**Subject: Response to Comments on 2020 Annual Groundwater Management Zone (GMZ)
Monitoring and System Performance Report
Hamilton Sundstrand Corporation Plant 1/2 Facility, Area 9/10 Remedial Action
Southeast Rockford Groundwater Contamination Superfund Site (ILD981000417)**

On behalf of Hamilton Sundstrand Corporation (HSC), AECOM Technical Services Inc. (AECOM) has completed this response letter to the United States Environmental Protection Agency (USEPA) August 24, 2021 comment letter regarding the 2020 Annual Groundwater Management Zone (GMZ) Monitoring and System Performance Report (AECOM, 2021a) for the HSC Plant 1/2 Facility in Rockford, Illinois (Site).

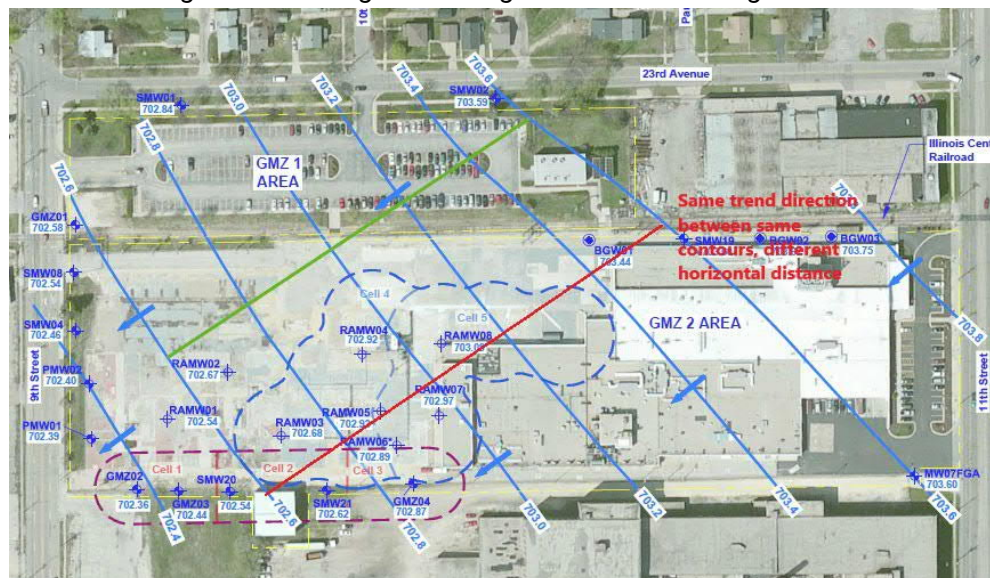
Comment 9: *Page 4-2. Paragraph 4 and Figures 3, 4, 5, 6. Hydraulic gradients appear to have been computed from contours which presupposes the contours are precisely placed relative to the data. The position of the green line on the figures is subjective and could easily be moved to indicate the same directional trend in a different area but calculating to a different gradient magnitude because the gradient line would be*

longer or shorter (see red line in figure below). It is recommended that the calculation of gradients across this Site be computed between two wells, one upgradient and one downgradient, for consistency from period to period; perhaps MW203 and GMZ01 or other matched pair on opposite sides of the Site that represent the general direction of flow.

Response: Calculation of hydraulic gradient should be performed parallel to leachate flow direction. As the USEPA notes, different gradients can be calculated across the site depending on where the line is placed. The use of pre-determined matched monitoring wells does not take into account slight variation of leachate flow direction which would result in a gradient line that is not perpendicular to leachate flow direction. However, per USEPA request, the hydraulic gradient will also be calculated from the matched pair of monitoring wells, SMW19 and SMW20. These two wells are closely aligned with the leachate flow direction and located near the center of the site. As a result, they will provide a good representative location from which to calculate the hydraulic gradient at the Site.

The text in Section 4.3 of the Revised 2020 Report presents a summary of the hydraulic gradient calculation for each of the four sampling events using both the hydraulic gradient line shown in each potentiometric figure, as well as by the gradient between wells SMW19 and SMW20. The gradient across the site shows little variability over the four sampling events and using the two different methods.

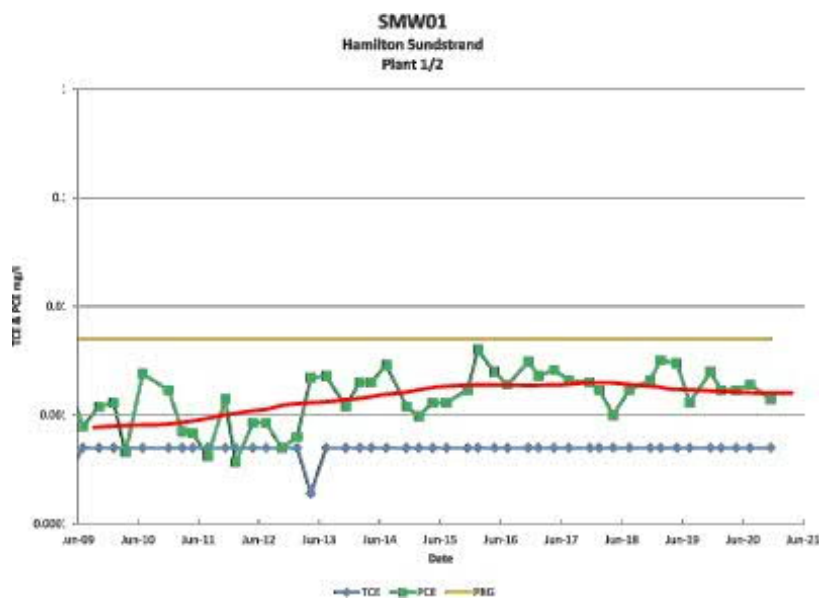
- b. *Last Sentence. This statement appears to be overconfident. When taken in shorter periods of time, there are multiple increasing trends in the time series data. Also, SMW01 shows an increasing trend in PCE in the overall time series plot (see plot below). For further clarification see EPA's 1Q 2021 Comment Letter (General Comment #3) regarding trend interpretation(s). Furthermore, how are conditions downgradient improving as downgradient of the western GMZ 1 and 2 boundary, sample results are not presented/assessed?*

Response: Taking the data series in shorter periods of time and focusing on periods of increase incompletely characterizes these data. For the SMW01 example, taken in shorter periods of time, the most recent time periods show stable and decreasing trends in the time series data. The red line drawn in the plot suggests a slight increase up to June 2015, but then suggests relative stability through June 2018 and then a slight decrease from June 2018 through the present. Taken as a whole, the SMW01 PCE data show concentrations that are below the PRG and indicate increasing concentrations were a previous

and temporary phenomenon. The last 6 years of data indicate SMW01 PCE concentrations remain below the PRG and are stable or decreasing.

Furthermore, monitoring well SMW01 is a cross-gradient well and is not located within the HSC facility. Impacts at this well are not related to the HSC facility.
